APPLICATION FOR LAND USE CONSISTENCY DETERMINATION
San Mateo County Airport Land Use Commission
C/CAG ALUC

Project Name: 2025 Oyster Point Specific Plan Update

Subject: San Francisco International Airport's Comments on the Land Use Consistency Determination for 2025 Oyster Point Project Specific Plan Update

Exhibit IV-6

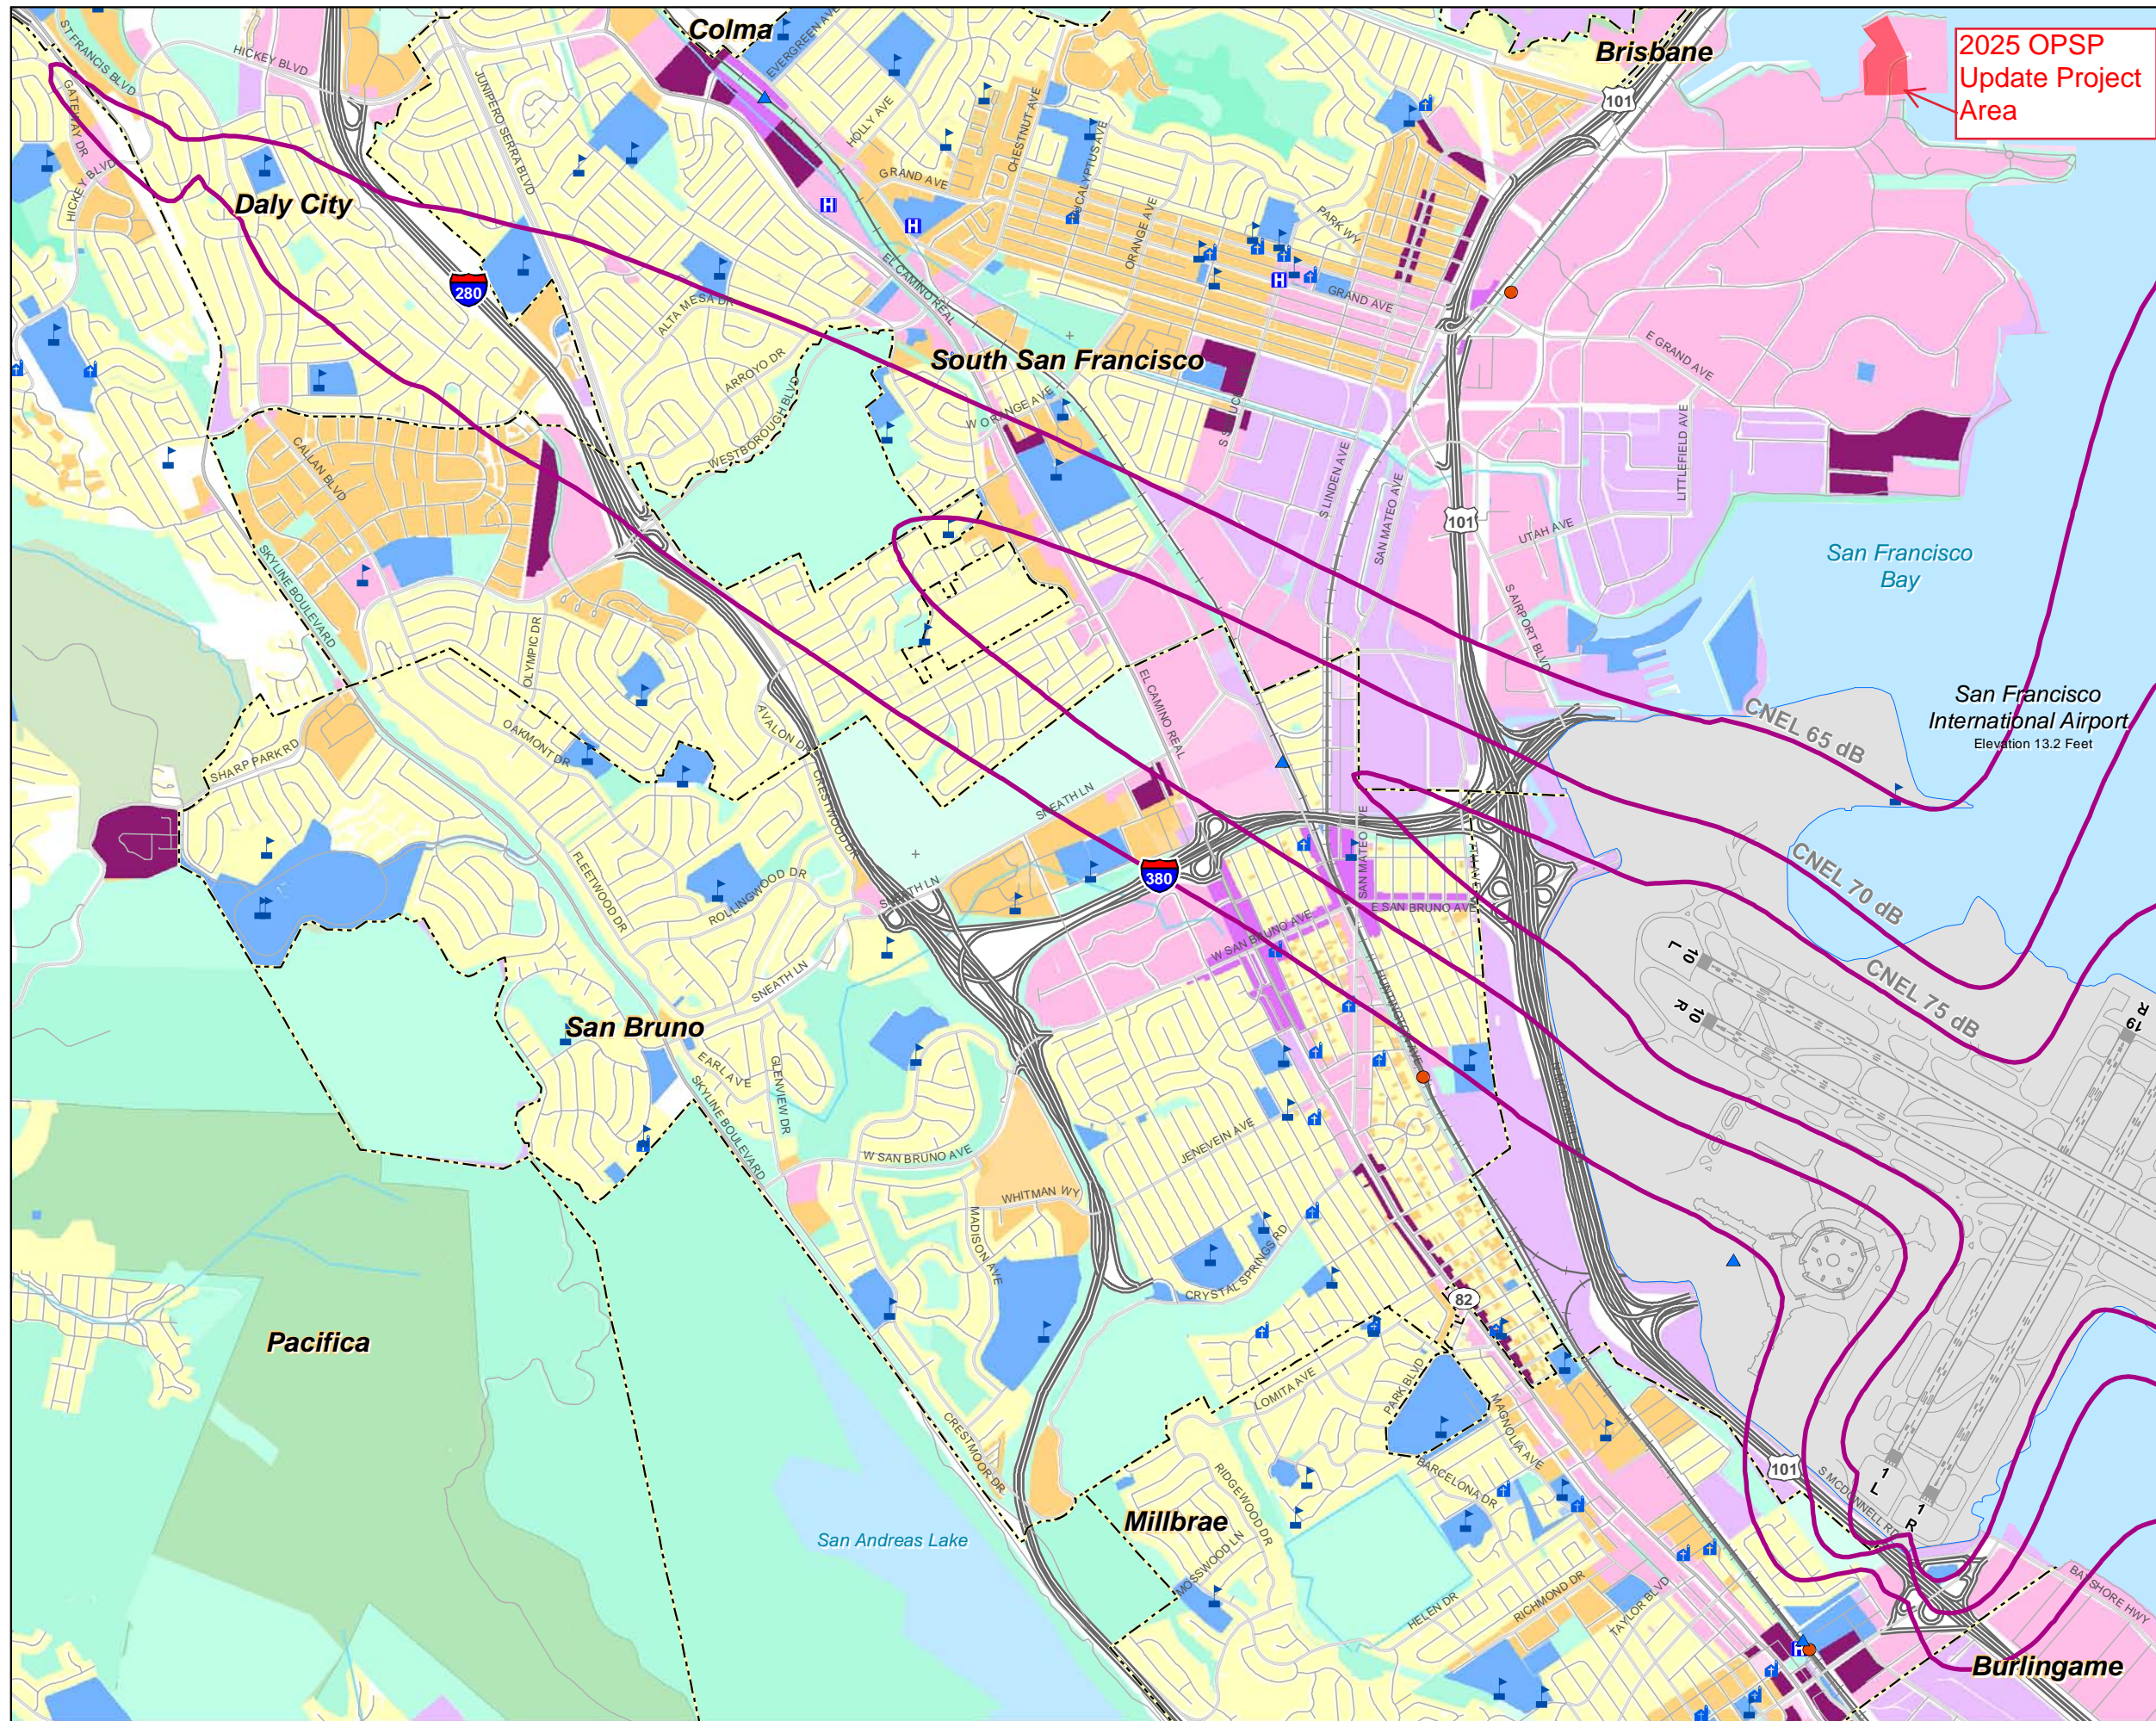
ALUCP Exhibit IV-6 “Noise Compatibility Zones – Detail” (see [Attachment 4](#)) indicates that the OPSP Project area is located well outside of the airport’s noise-affected 65 dBA CNEL noise contour.

The Proposed Project site is located outside the Airport's 65 dB Community Noise Equivalent Level (dB CNEL) noise contour. Therefore, the project does not appear to be incompatible with the noise compatibility policies of the SFO ALUCP. The Airport would like to remind the project proponent that while the area is outside of any defined noise zones, it does experience frequent overflights, particularly at night, as a result of noise abatement procedures designed to avoid overflights of residential areas. The project proponent should take this into account as they develop the site.

EXHIBIT IV-17
CRITICAL AERONAUTICAL SURFACES
 — NOR THWEST SIDE
 Comprehensive Airport Land Use Plan
 for the Environs of San Francisco International Airport
CICAG
 City/County Association of Governments
 of San Mateo County, California

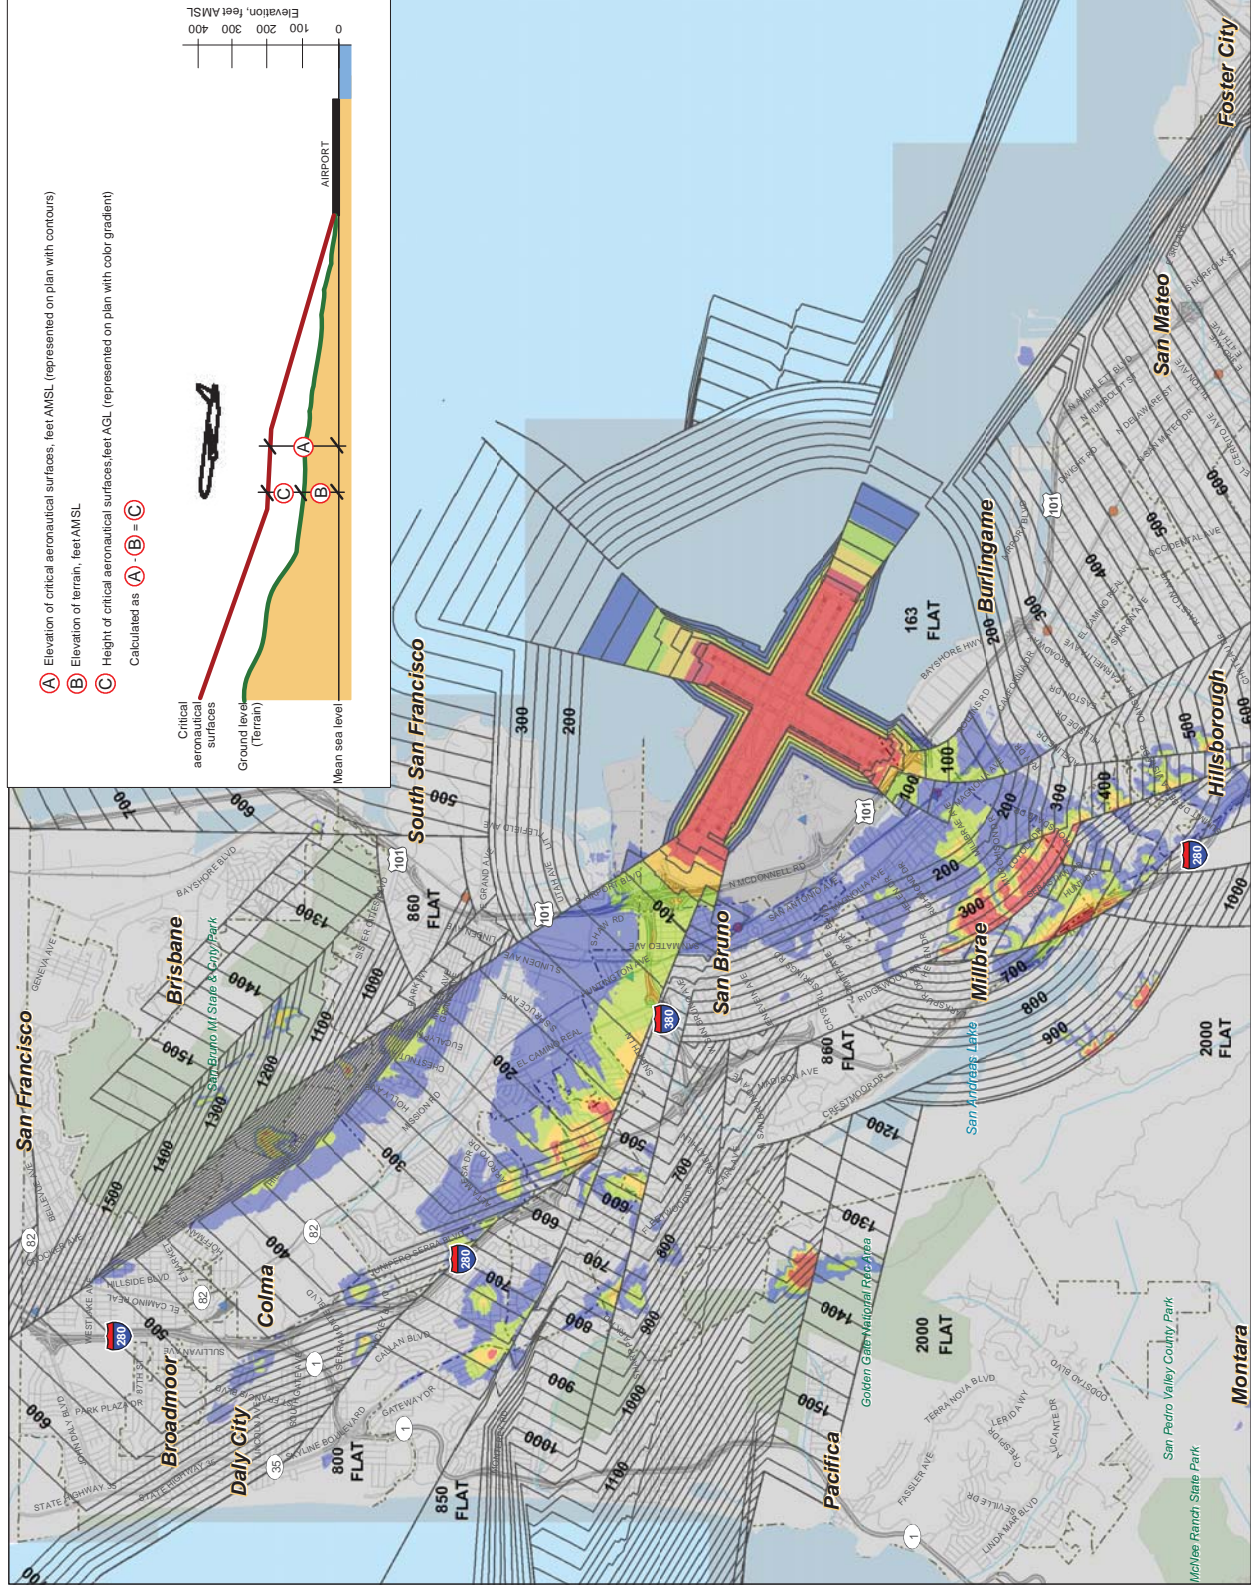
The Proposed Project is located beneath the critical aeronautical surfaces for Airport operations. As described in Exhibit IV-17 (see **Attachment A**) of the SFO ALUCP, the elevations of the critical aeronautical surfaces above the Proposed Project site are at least 300 feet above mean sea level, as defined from the 0-foot origin of the North American Vertical Datum of 1988 (AMSL NAVD88). Ground elevation at the Proposed Project site ranges from 15 to 17 feet AMSL NAVD88. While the proposal does not specifically list heights of the new buildings, there is reference to proposed maximum building heights of approximately 270 feet. If the proposal remains consistent with these heights, it would not appear to be incompatible with the airspace protection requirements of the SFO ALUCP. The Airport emphasizes that no portion of the permanent structures, including any antennas, appurtenances, davits, or architectural parapets, may penetrate the critical aeronautical surfaces defined in the SFO ALUCP.

This evaluation does not waive the requirement for any developments which result from the Proposed Project to undergo Federal Aviation Administration (FAA) airspace review as described in 14 Code of Federal Regulations Part 77 and in Exhibit IV-10 of the SFO ALUCP for both (1) the permanent structures and (2) any equipment taller than the permanent structures required to construct those structures. The FAA requires notification of proposed construction for any project that may have a potential effect on air navigation facilities. FAA Form 7460-1, Notice of Proposed Construction or Alteration, may be submitted by the project sponsor through the FAA's Obstruction Evaluation/Airport Airspace Analysis website (<http://oeaaa.faa.gov>). A Determination of No Hazard from the FAA should be obtained prior to project approval.
